Serial No. 10/066,764

Docket No. K-0392

Reply dated **February 11, 2004**

In Response to Office Action dated October 17, 2003

FIG. 7

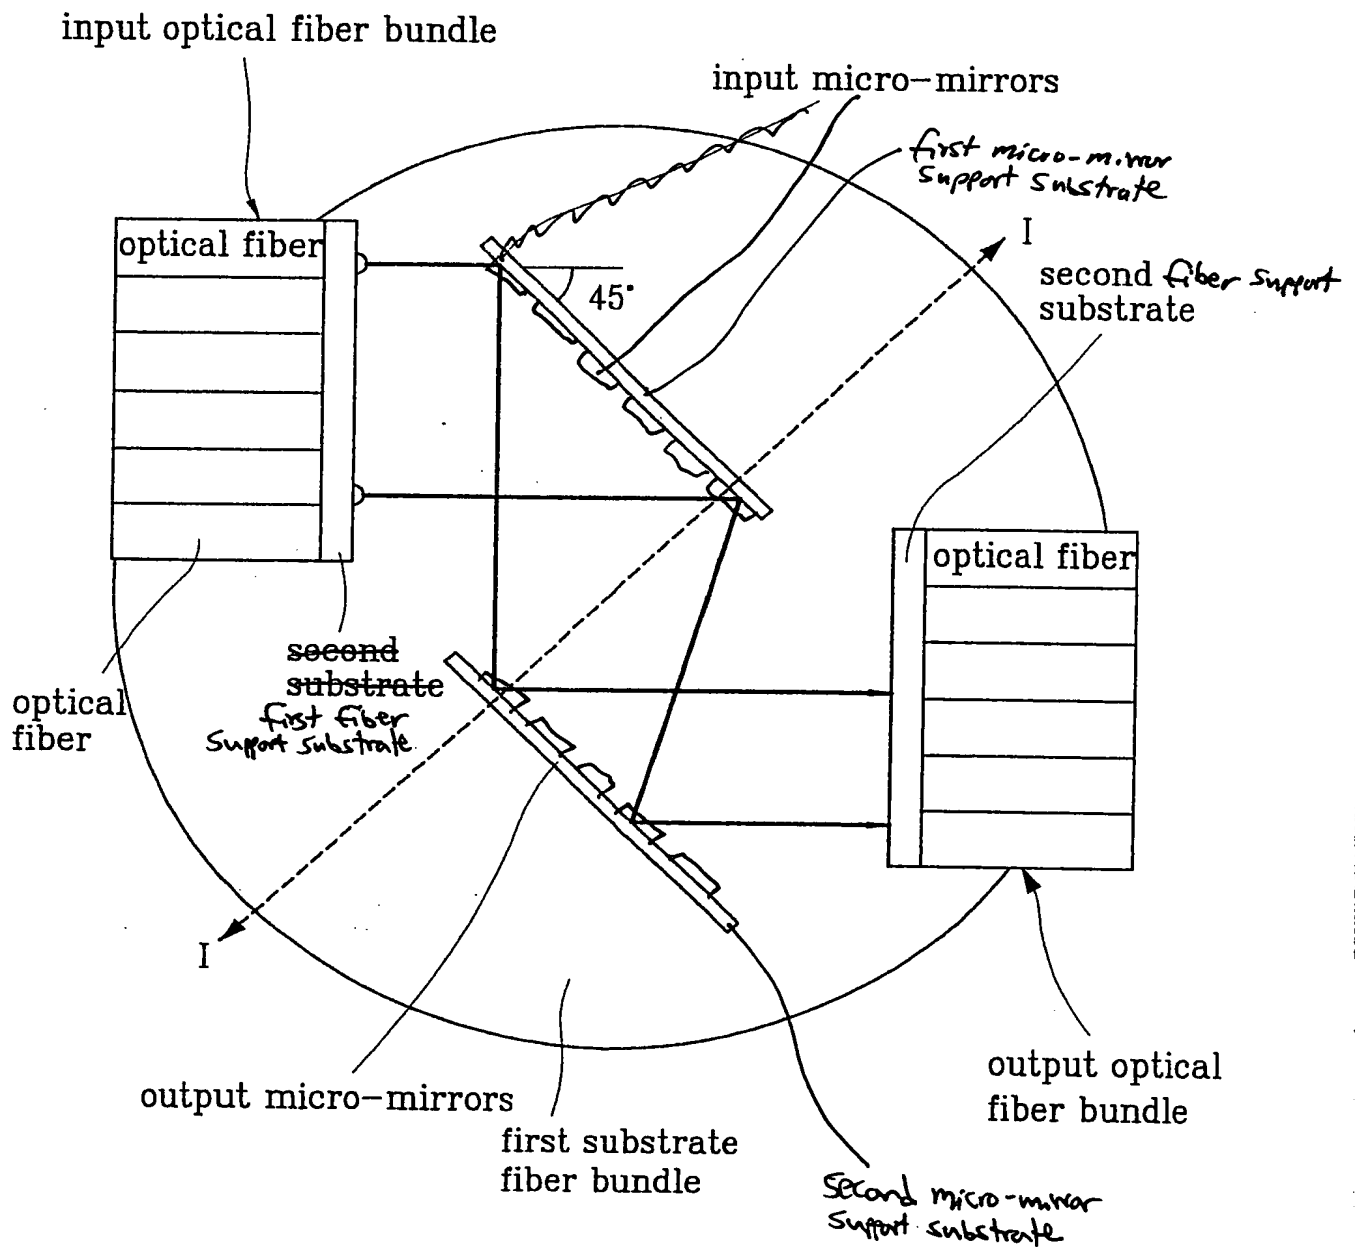
The Office Action objects to the drawings under 37 C.F.R. 1.83a because the drawings allegedly do not show every feature of the invention specified in the claims. Figs. 4 and 7 have been amended, as shown in the attached replacement sheets, to add labels for the first and the second fiber support substrates and first and second micro-mirror support substrates. In addition, the specification has been amended to conform to the drawings. No new matter has been added.

Claims 1-7 and 9-11 are pending in this application. By this Amendment, claims 1, 2, 4, 6 and 9 are amended, and claim 8 is canceled without prejudice or disclaimer of the subject matter therein. In addition, Figs. 4 and 7 have been amended to correct informalities. Replacement sheets that include corrected Figs. 4 and 7 are attached.
